AJHajh-20220125-ArunCrem Planning Response_LPA.docx

Y/184/21/DOC – CONDITIONS 8, 9 AND 10: DRAINAGE RESPONSE

Thank you for returning comments from your Drainage Engineer pertaining to planning conditions 8, 9 and 10 under planning permission Y/184/21/DOC for the Crematorium, Bognor.

Proposed Finished Levels Layout

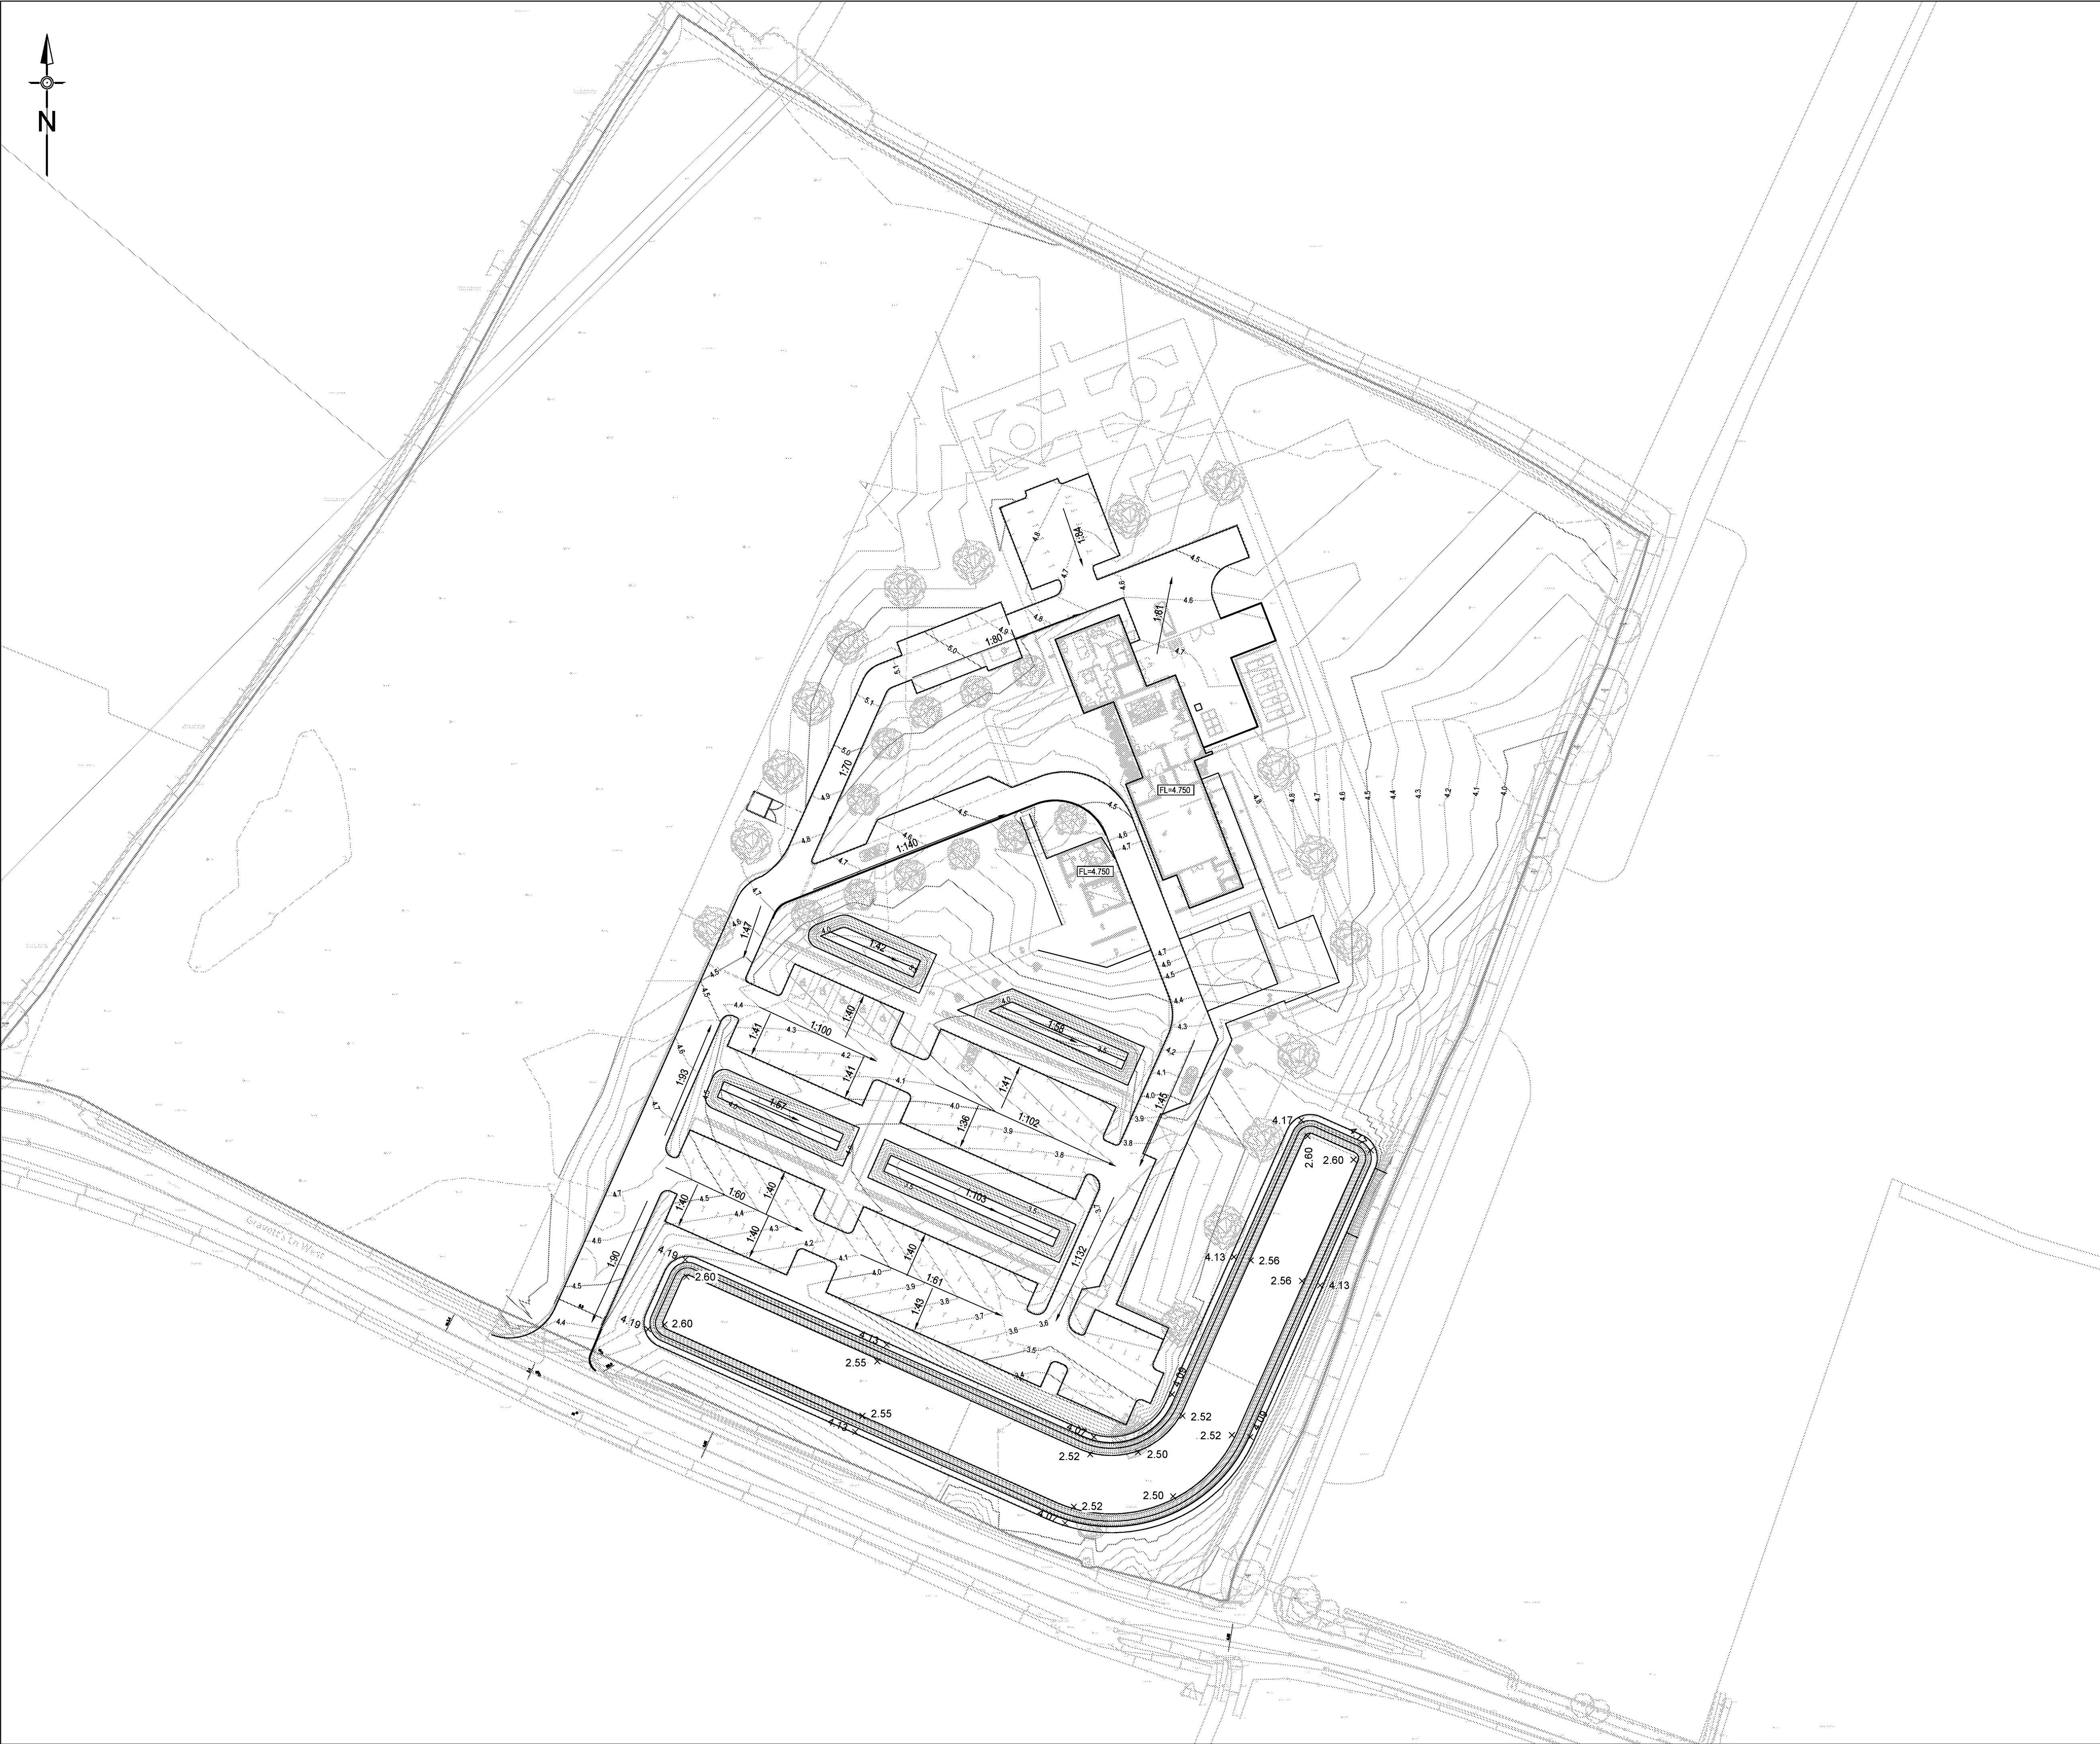
1. *Please supply results of winter groundwater monitoring and winter infiltration testing.*
2. *Please supply calculations to support design.*
3. *Please supply an impermeable area catchment plan.*
4. *Please label all pipes with diameter and fall.*
5. *Hydrobrake unit references should be included on layout plans.*
6. *Please label finish and formation level of permeable paving.*
7. *Gullies and channel drains should be labelled with cover levels.*
8. *The gabion outfall construction detail drawing is unclear. Is it proposed to have buried pipes discharging to the basin?*

be obtained from levels plan *13591-CRH-XX-XX-DR-C-5200 Revision P3* and sub base levels inferred (Minor updates to Revision P3 enclosed for completeness).

Drainage Construction Details Proposed Basin Detail

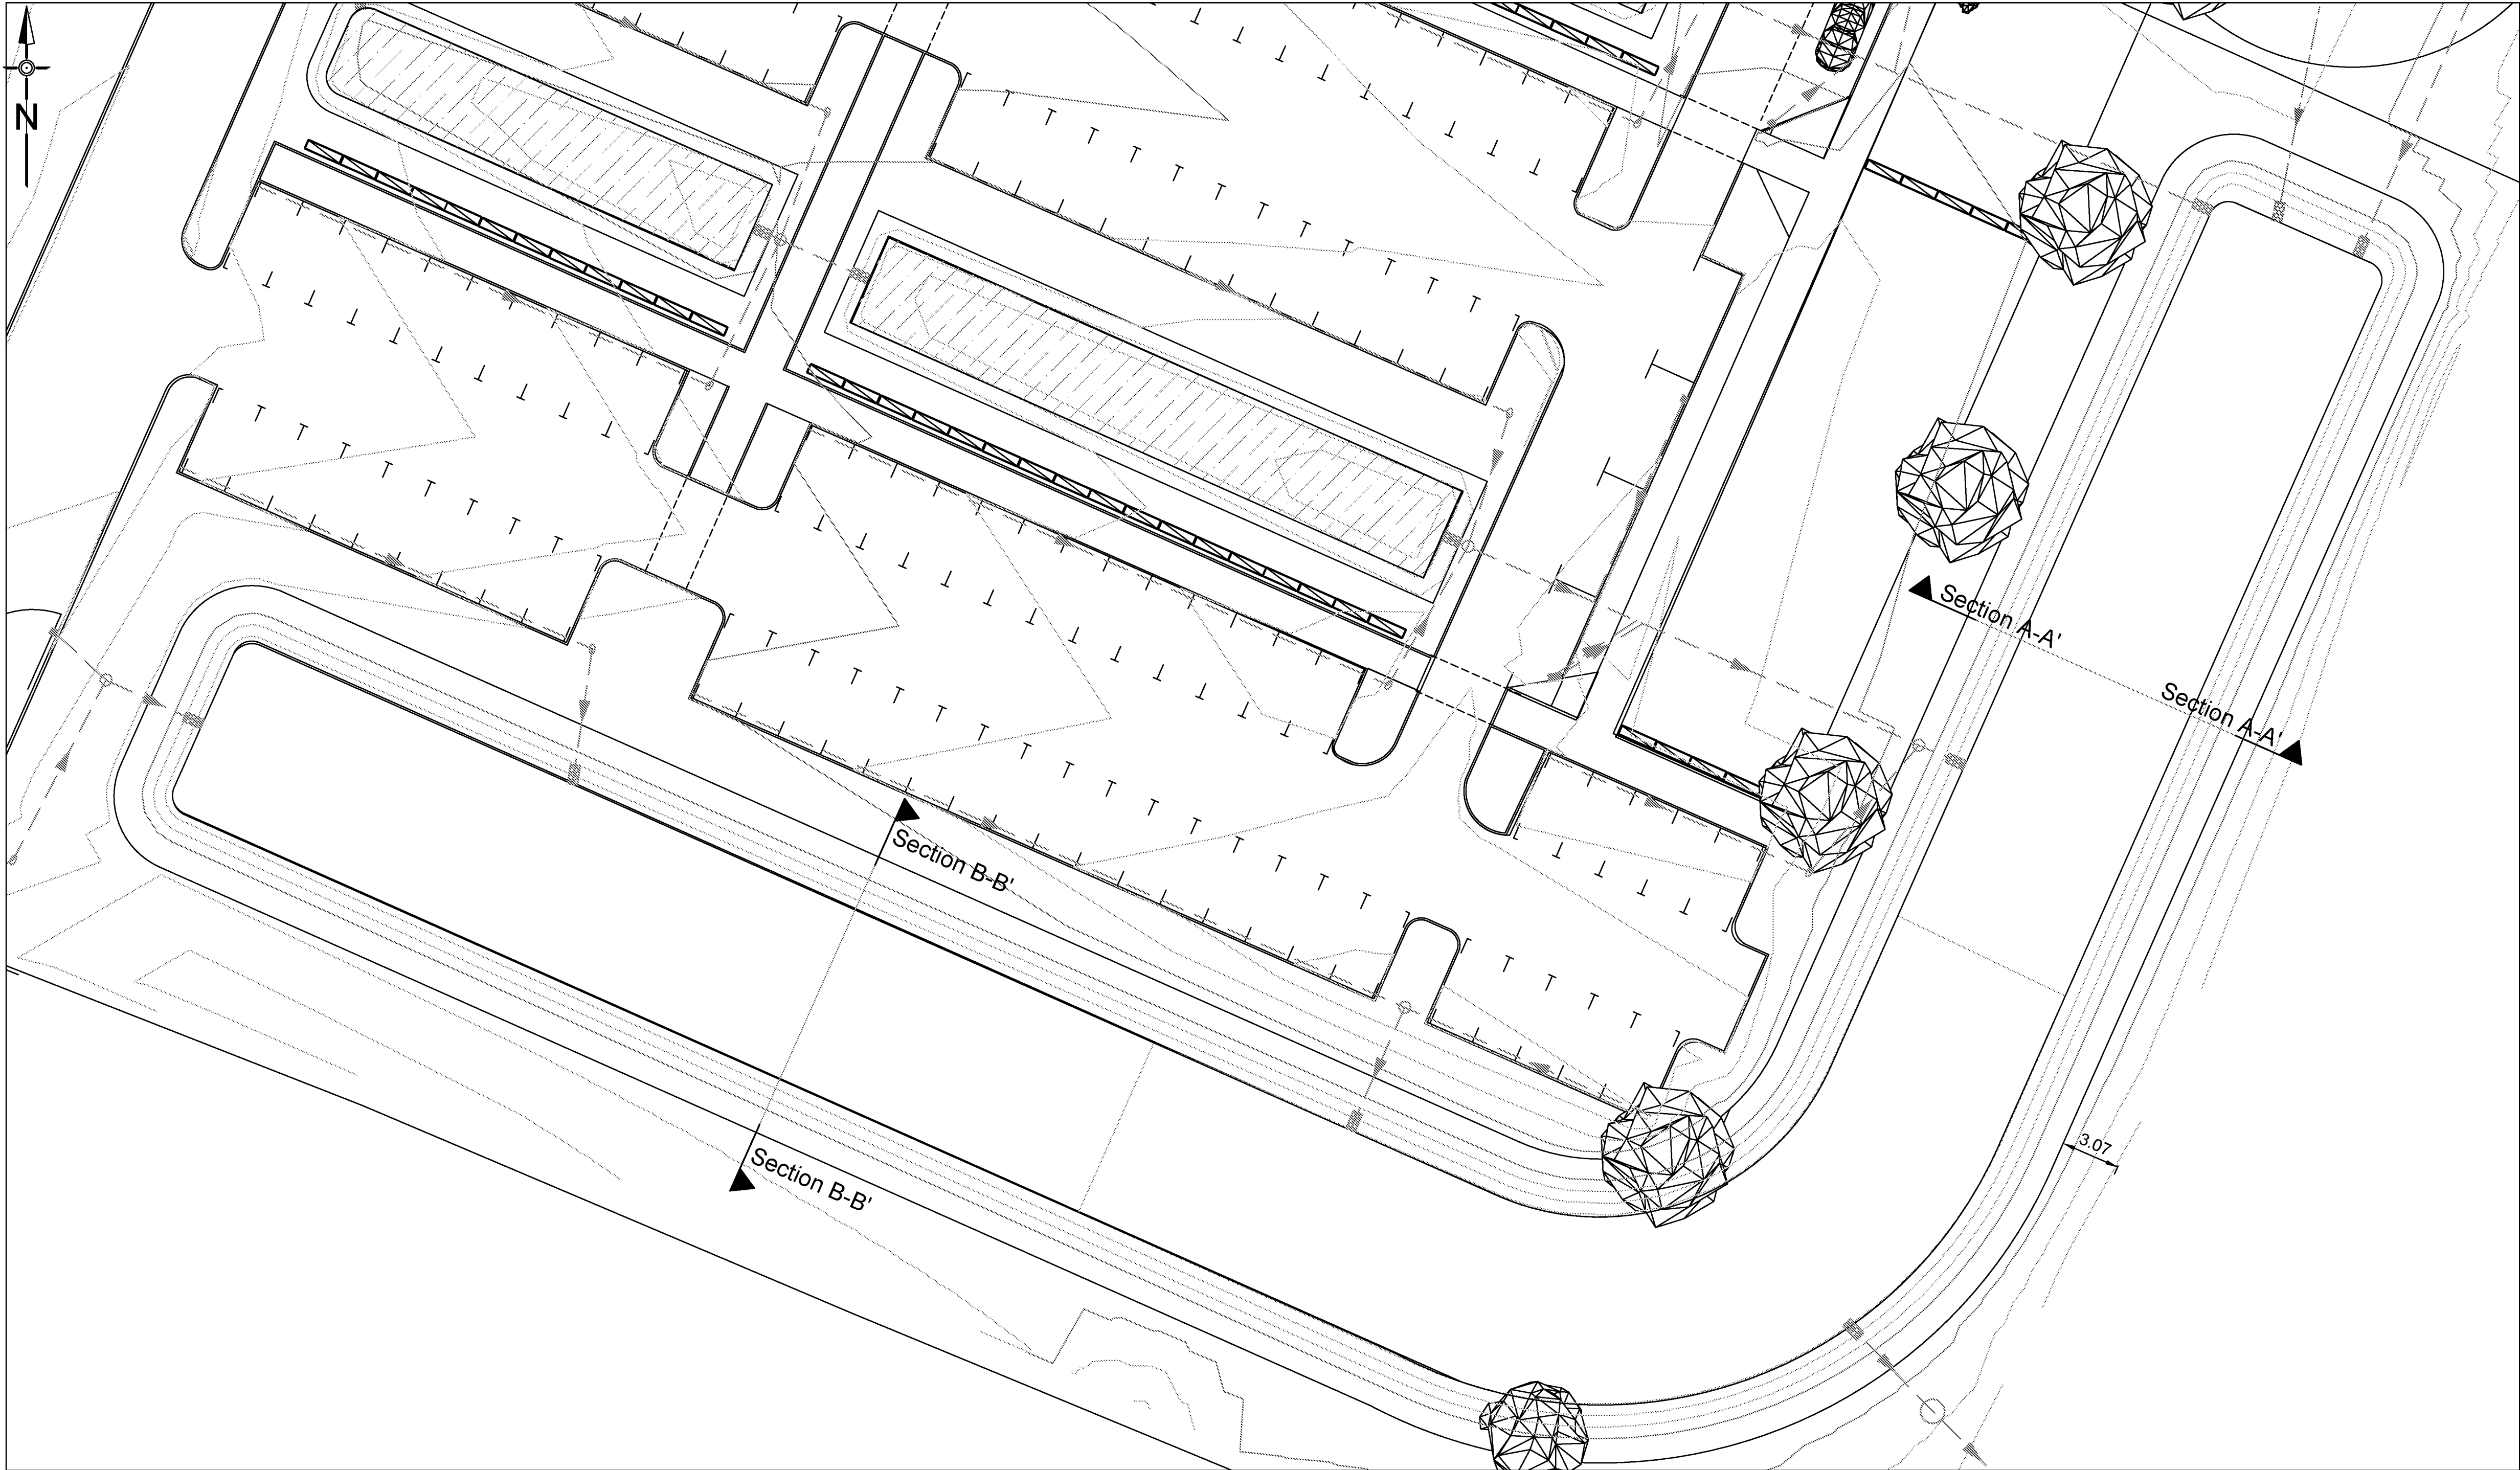
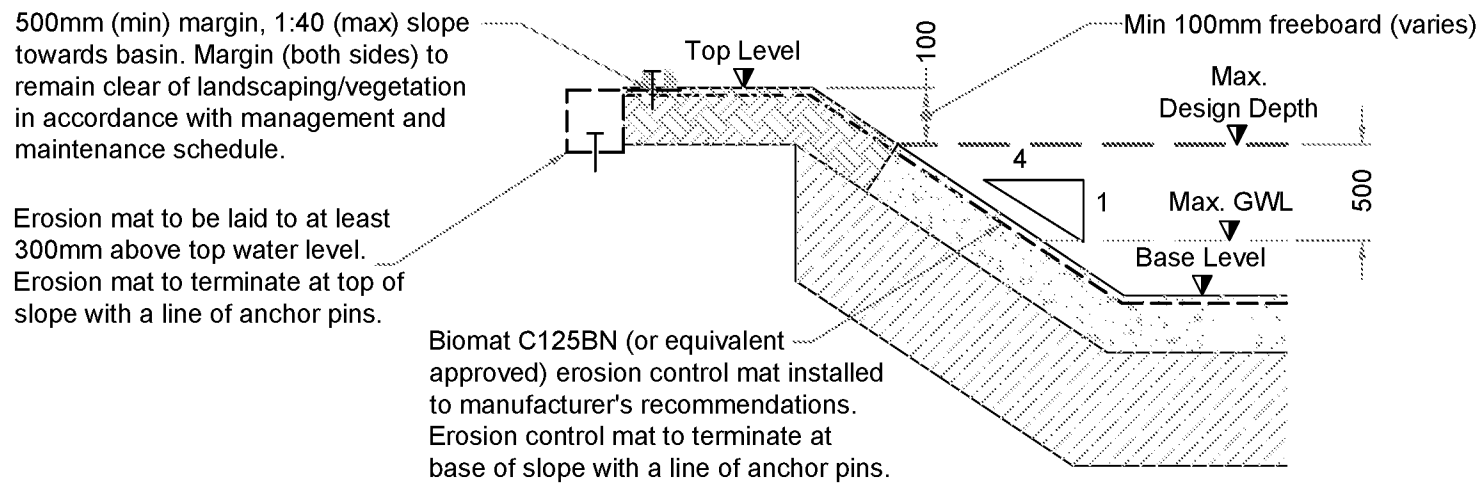
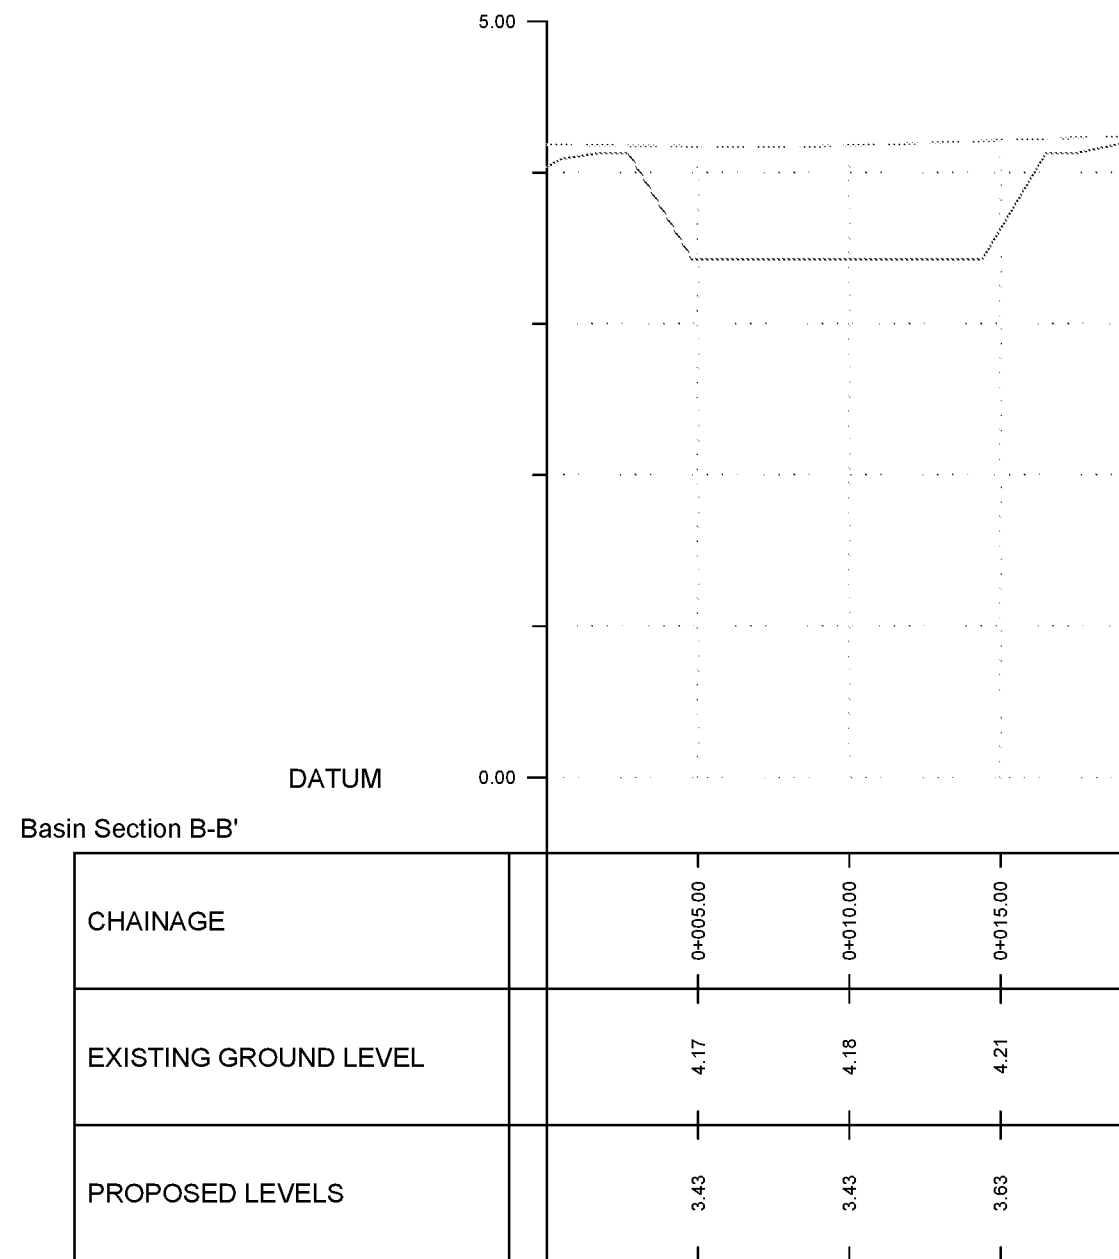
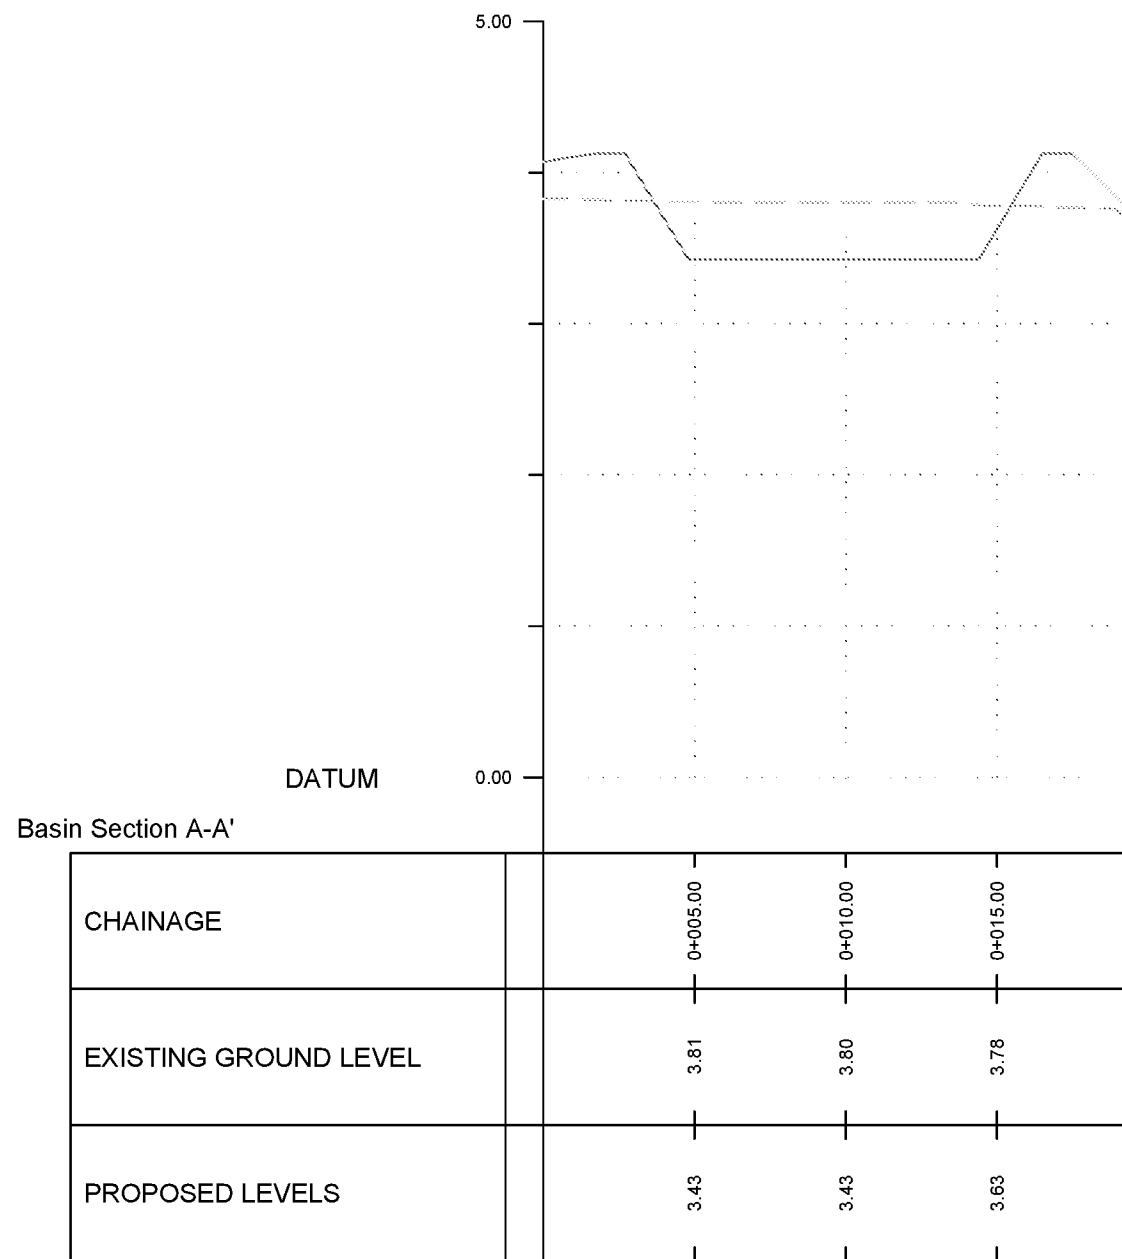
9. Please supply site specific construction details of the attenuation basin, showing invert level, top of bank level, width at bed and width at bank.

9. Please see enclosed basin detail drawing *13591-CRH-XX-XX-DR-C-5310 Revision P1*.
